| Office Action Summary | Application No. 10/590,638 | Applicant(s) RAMSAUER, DIETER | |

DETAILED ACTION

Fig. 3

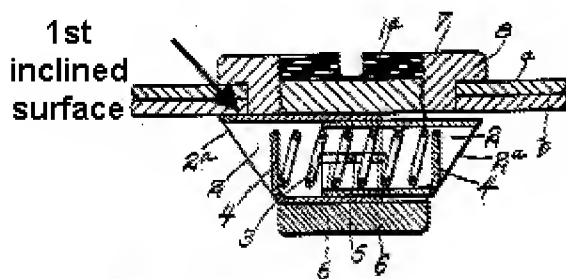
1. Claims 28-29, 31, 34 are rejected under 35 U.S.C. 102(b) as being anticipated by (Witzberger US 1426239).
2. Regarding claim 28, Witzberger teaches a latch for mounting in a thin wall (plates a,b) having a head part (8) arranged outside a thin wall which overlaps an outer rim of the opening, a body part (1) which proceeds from the head part and projects through the opening in the mounted position, holding elements (2) which project from the body

part and are displaceable in a direction of the elements' outer surfaces, a free end of the holding elements being provided with a first inclined surface (see figure below – Please note that “inclined” is defined as “tending in a direction that makes an angle with anything else” –source: Dictionary.com. Therefor without a reference the surface as labeled below can be considered inclined. Further, please note that if applicant intended to claim that the surface is inclined with respect to the wall; please see applicant's provided art 883121 where surface 22 is at an incline. Please note that 883121 is used for support and is not part of the rejection) for supporting the body part without play on the rim wherein the first inclined surface rests on the rim of the opening in the mounted position wherein said free end of said holding elements being further provided with a second inclined surface (2a) for slam action, the second inclined surface being approximately at a right angle to the first; wherein the holding elements are slides that diametrically oppose each other; the body part and the holding elements being separate parts and are arranged to be displaceable in the cylinder of the body part parallel to the plane of the thin wall.

3. Regarding claim 29, the slides are held against a pressure spring force (3) by a hook arrangement (slots 6 hook onto pin 5).

4. Regarding claim 31, Witzberger teaches the claimed limitations as applied to claim 28 above and further teaches that the slides are rigid and held by a spring force (3) and a pin arrangement (5/6).

5. Regarding claim 34, the cylinder has an opening edge where (the edge where the slides extend from) the slides are supported axially by a shoulder or hook (they are hooked at 5).
